RE: Development Application 2019/143

Consultant Advice Notice
Bangus Quarry Landfill Development, Tumblong NSW
Noise Impact Assessment – EPA Questions (DOC 19212921-39)

Soils and Water report Proposed Stockpile Erosion and Sediment Control Measures

BANGUS QUARRY LANDFILL VOLUMES AND AREAS ASSESSMENT

Further information on location and layout of proposed ESC measures is provided on '*Figure 1 – Conceptual ESC Plan*' accompanying this letter.

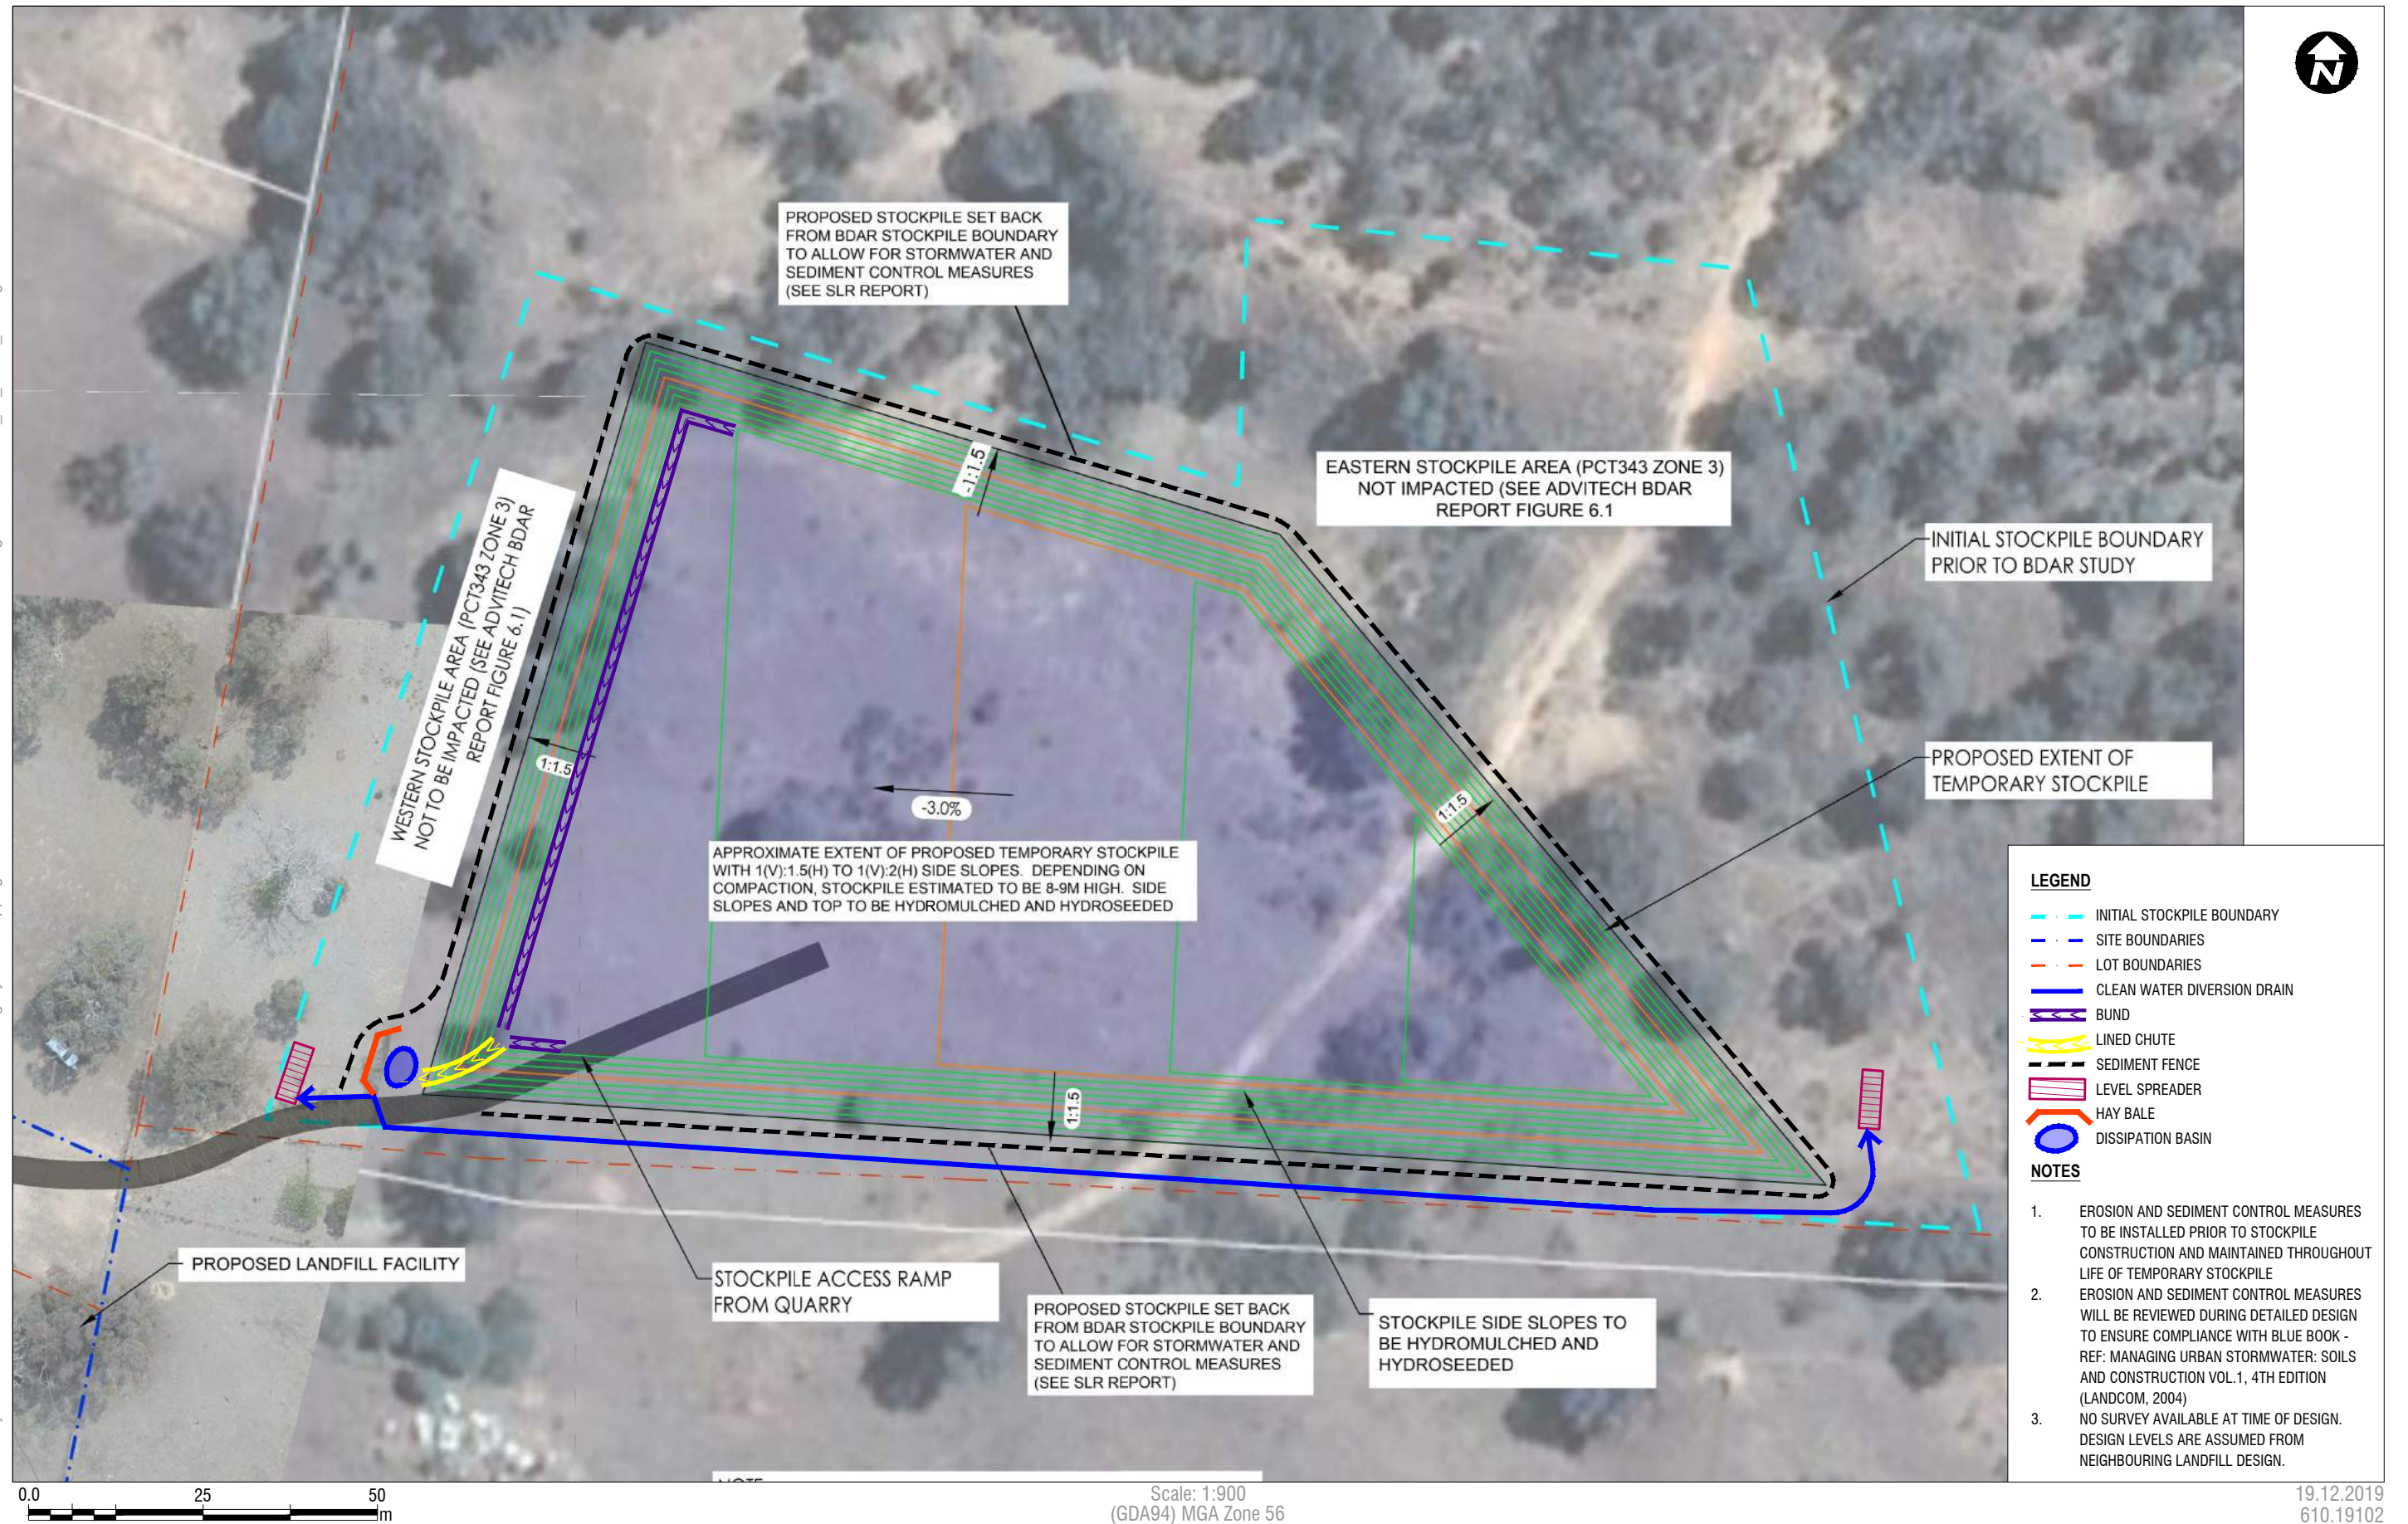
This letter has been prepared as an addendum to SLR's Soils and Water report '610.19102-R01-v0.4', to address comments by the EPA dated 17th December 2019 with regard to additional erosion and sediment controls (ESC) required for the stockpile of materials on adjacent land.

The following ESC measures are proposed to manage the disturbed area associated with the stockpile:

Clean Water Diversion Bunds

Clean water diversion bunds will be constructed upslope of the proposed stockpile to divert any clean water runoff before it contributes to generating sediment runoff over the disturbed area.

Sediment Fencing

Sediment fencing will be implemented downstream of the disturbed area to capture any sediment runoff generated by activities associated with operations around the stockpile.

Stockpile

InSitu Advisory mentioned that the stockpile will need to hold up to 108,000m³ and will likely be in place for approximately 8 years (worst case scenario used to prepare this conceptual ESC plan addendum). An inner bund will be constructed on top of the stockpile to redirect runoff towards a chute built into the access track and leading to a dissipation basin.

The proponent intends to hydromulch and hydroseed the side slopes and crown of the proposed temporary stockpile and maintain the vegetative cover for the duration of the stockpile operation.

When a better understanding of the stockpile geometry is known (which is dependent on continued removal of quarried materials by Council and the factors such as compaction rates during stockpiling) a more detailed ESC plan will be generated. Appropriate measures will be constructed to manage stormwater runoff and sediment control through engineered measures which may include additional ditches or swales and the possibility of a small stormwater collection pond within the adjacent stockpile lot. These additional measures will be developed using best practice and in accordance with blue Book requirements.
